Virgil C. Summer Nuclear Station (VCSNS) Units 2 and 3
Combined License Nos. NPF-93 and NPF-94
Docket Nos. 52-027 & 52-028

Subject: VCSNS Units 2 & 3 Request for License Amendment and Exemption:
Passive Core Cooling System (PXS) Condensate Return (LAR 16-06)

Proposed Changes to the Licensing Basis Documents (LAR 16-06)

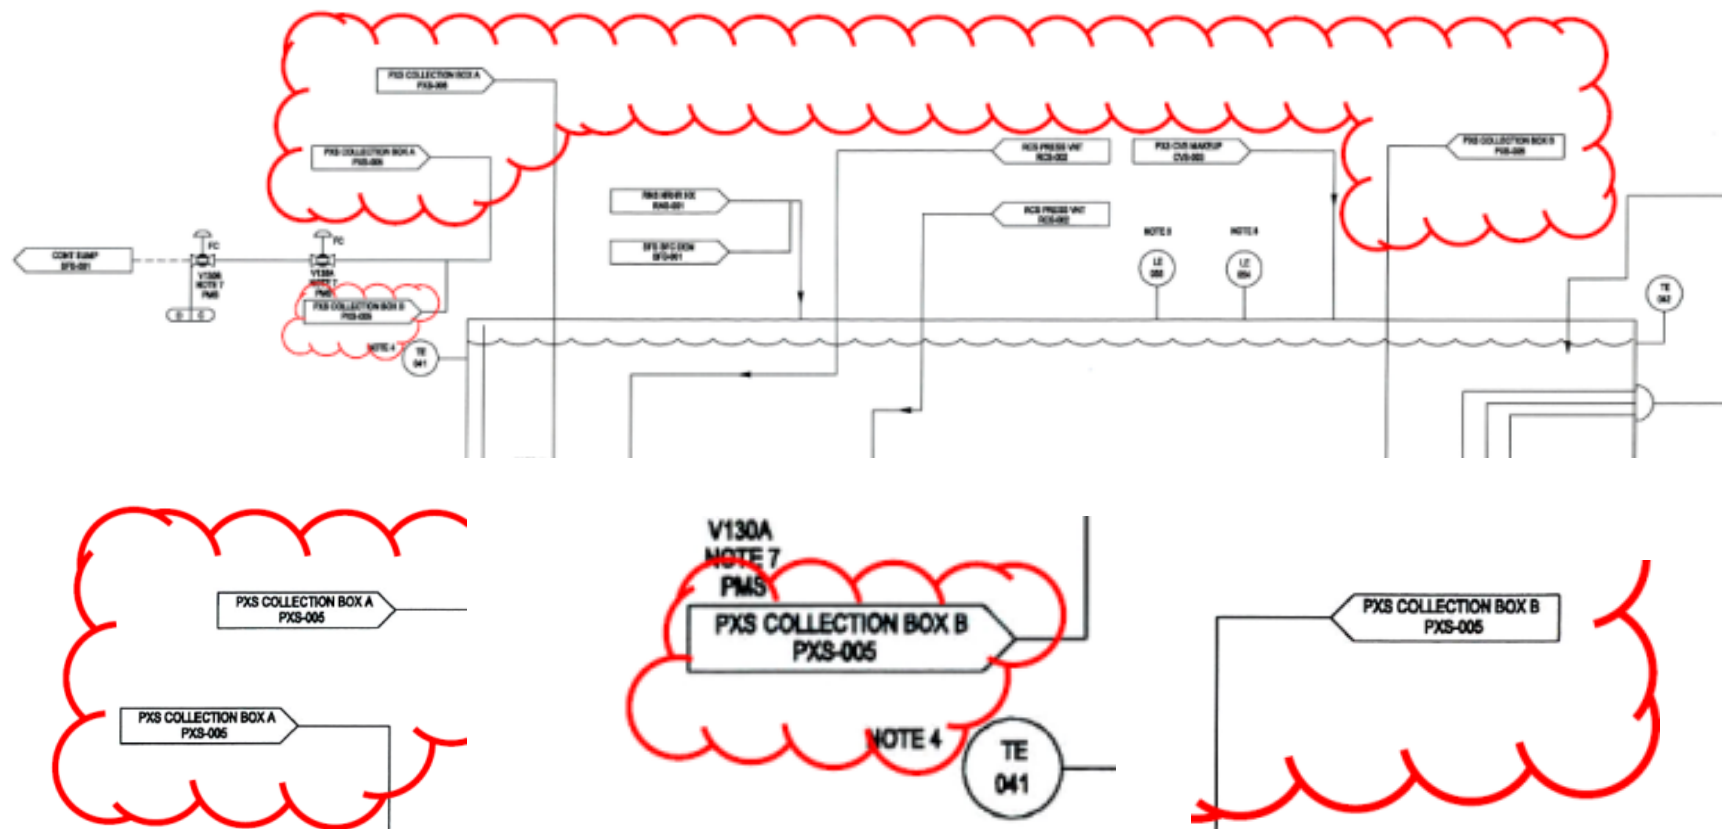
- Figure 6.3-1 is relabeled as “Figure 6.3-1 (Sheet 1 of 3).” This editorial change is the only change made to this figure. No technical changes are made.
- Figure 6.3-2 is relabeled “Figure 6.3-1 (Sheet 2 of 3).” On relabeled Sheet 2, the IRWST gutter is relocated to a new sheet 3 of the PXS P&IDs. Sheet 2 is modified to include continuation flags for condensate returning to the IRWST originating from PXS Collection Boxes A and B in the IRWST gutter.
- Figure 6.3-1 (Sheet 3 of 3) is a new P&ID sheet and is added to the licensing basis. This new figure shows the relocated IRWST gutter and the screens and piping comprising the PXS downspouts originating from the PCG and internal stiffener.

The UFSAR Section 6.3, Figure 6.3-2 is revised to become Figure 6.3-1 (Sheet 2 of 3) rather than Figure 6.3-2, and revised as identified below.

The UFSAR Section 6.3, Figure 6.3-1 (Sheet 2 of 3) [that was Figure 6.3-2] is revised in the upper portion of the figure to relocate the IRWST gutter to a new sheet 3, and to include continuation flags for condensate returning to the IRWST originating from PXS Collection Boxes A and B in the IRWST gutter as shown below. Individual flags are shown larger for clarity below.

New UFSAR Section 6.3, Figure 6.3-1 (Sheet 3 of 3) is included to show the downspout collection system as provided below.

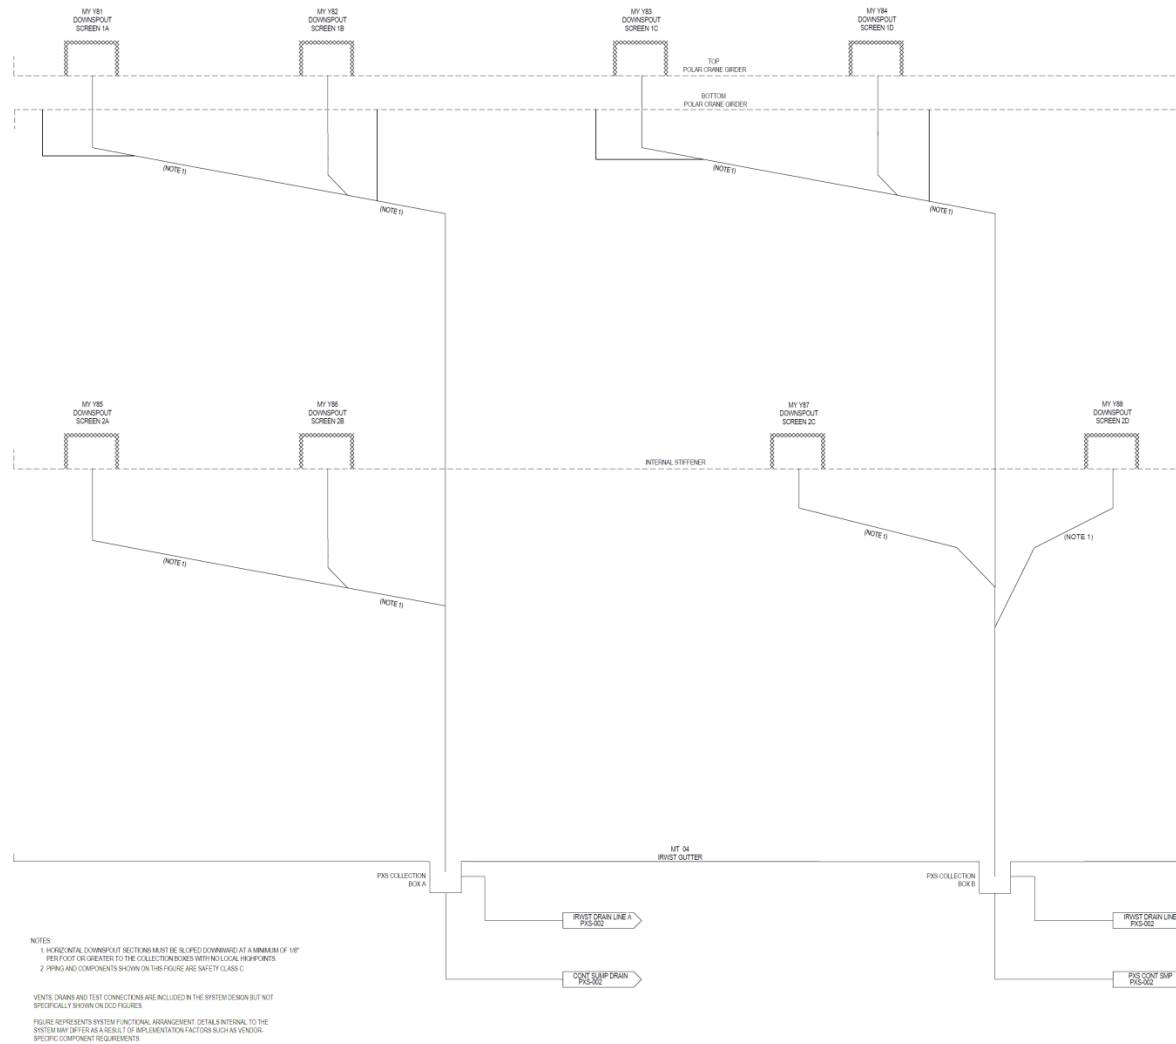
The UFSAR Section 6.3, is revised to include a new Figure 6.3-1 (Sheet 3 of 3), as identified below.
